**NOTICE OF ADDENDUM  
ADDENDUM NO. 1  
Hawks Landing Hydrology Study  
CONTRACT NO. 7833**

### Request for Proposal

**Hawks Landing West Ponds**

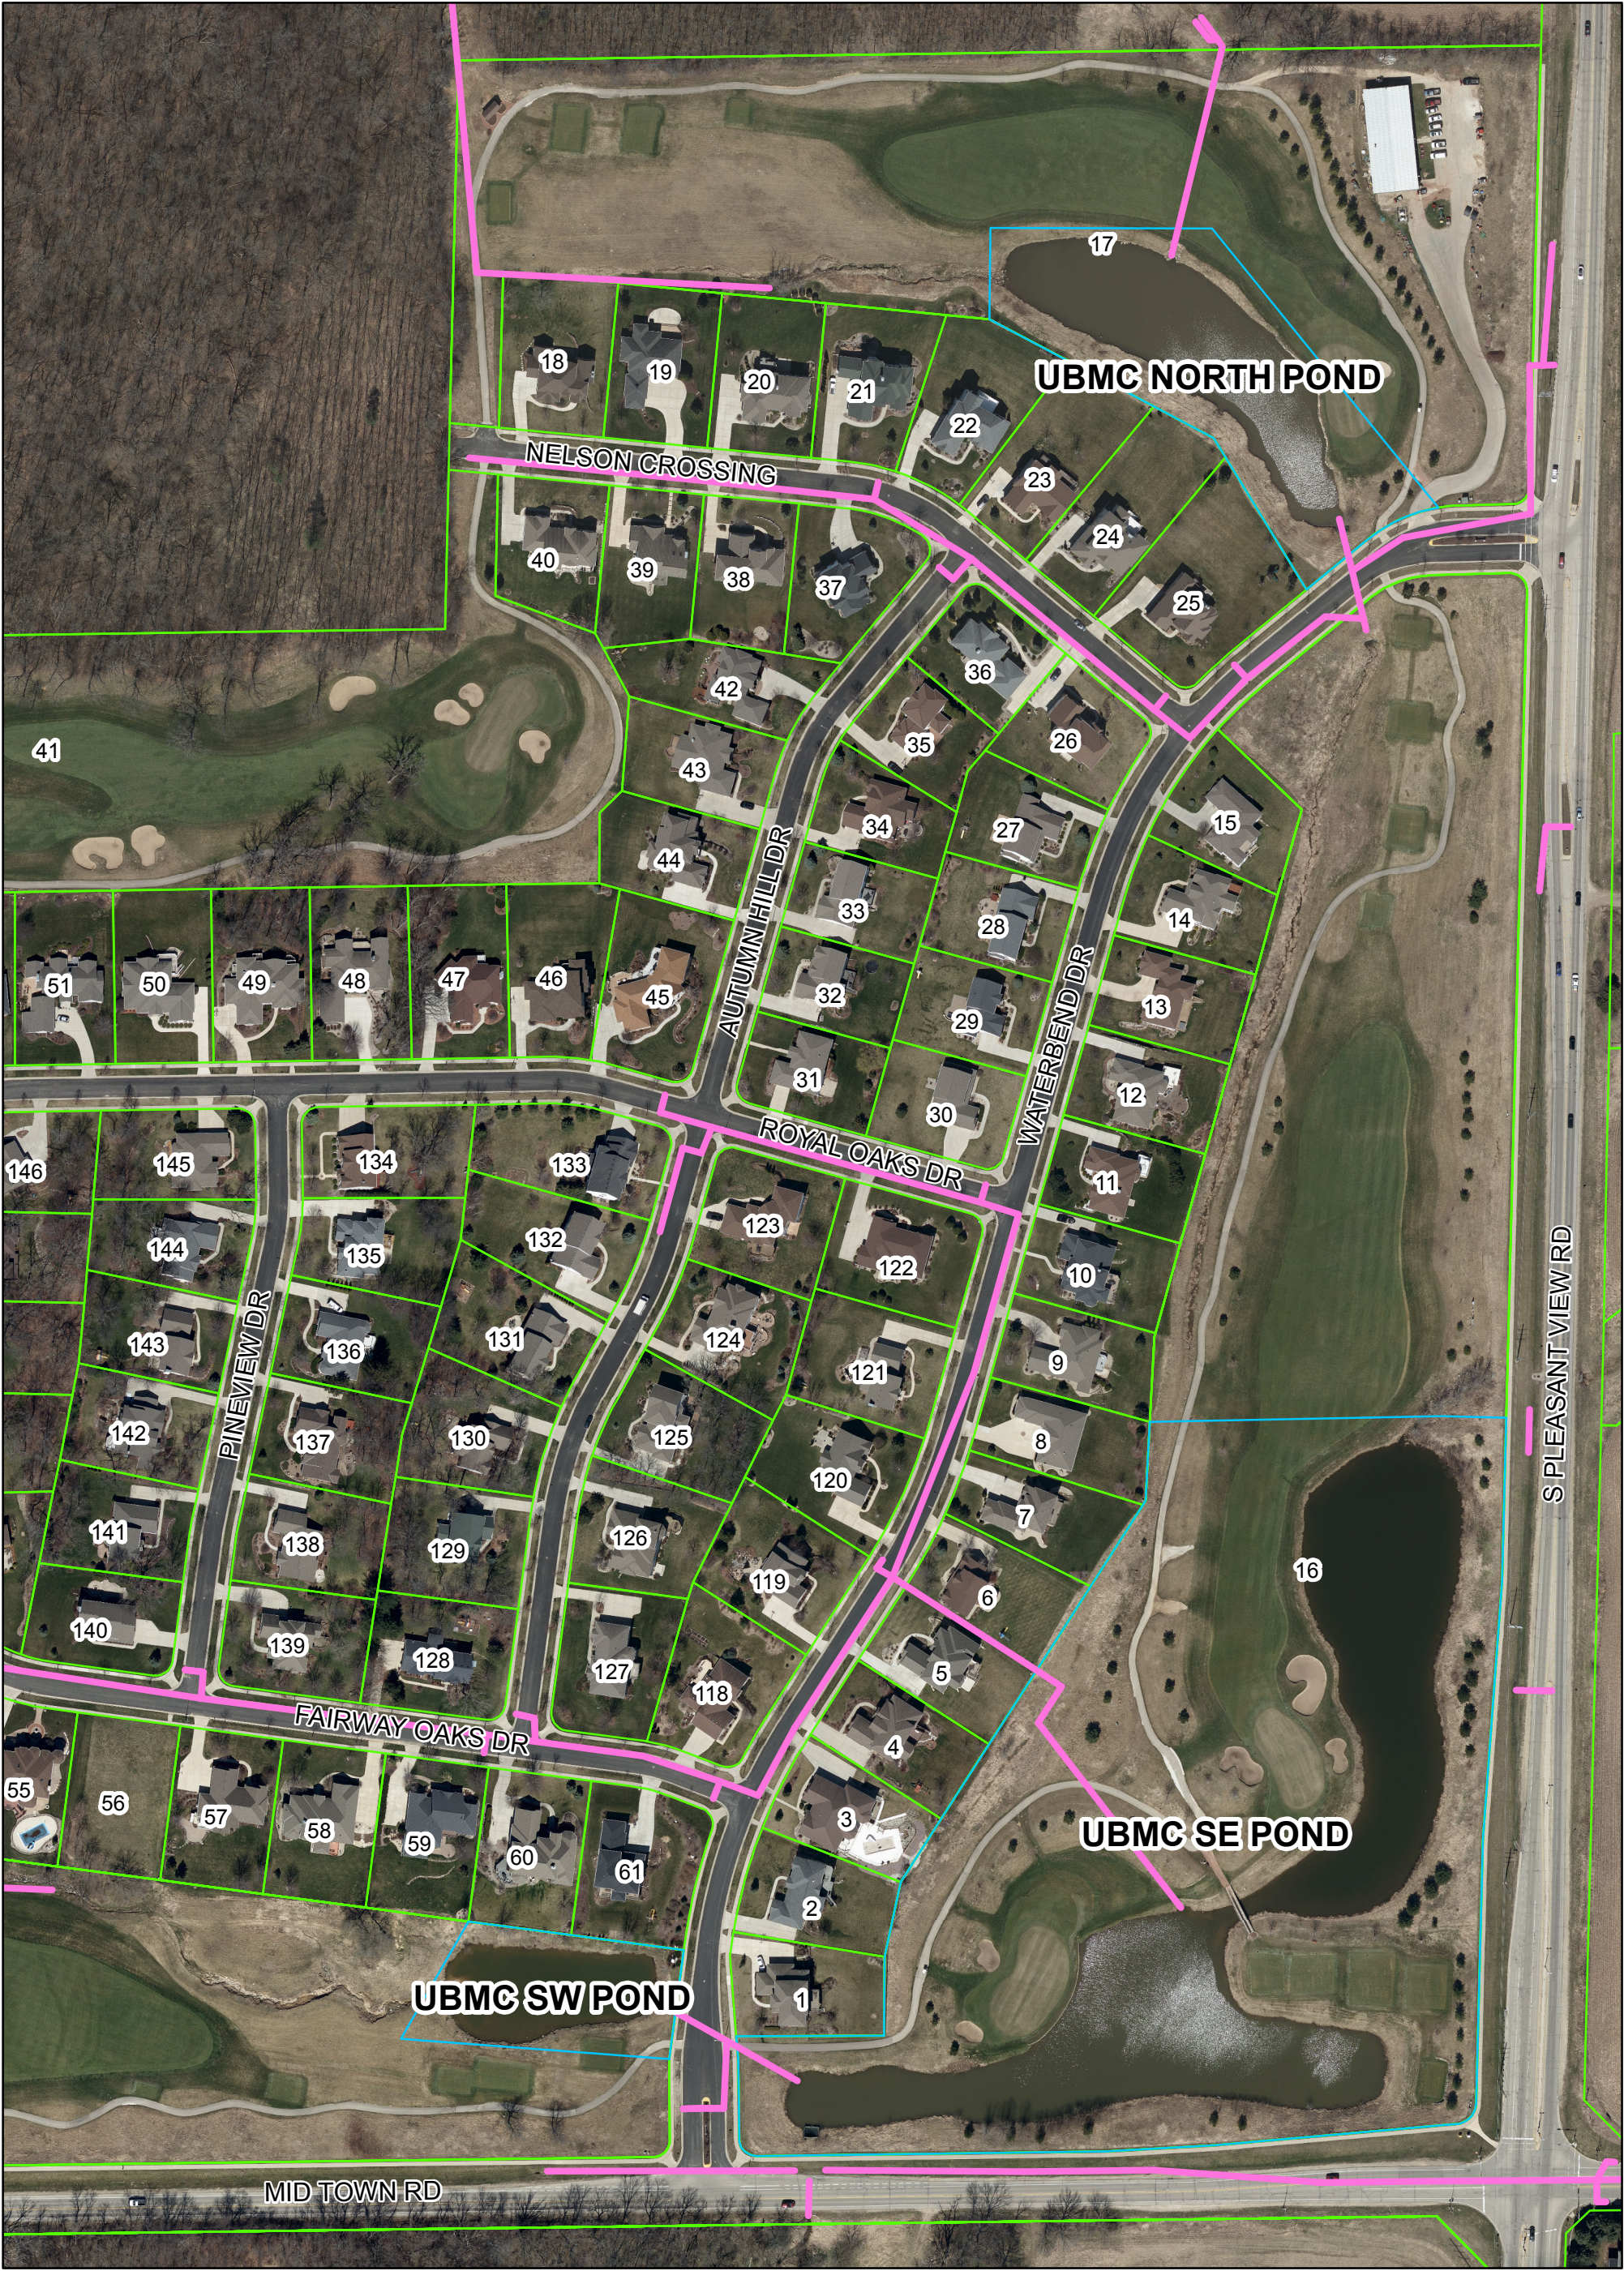
2. Section 2.10, "Schedule for Design Services": Proposal deadline has been changed. Proposals are now due to the office of the City Engineer on Friday, October 14, 2016 at 4:00pm. The City Engineer's office is Room 115 of the City/County Building at 210 Martin Luther King Jr. Blvd.
3. Figures 2A and 2B: Replace Figures 2A and 2B in original RFP with Figures 2A and 2B attached to this addendum.
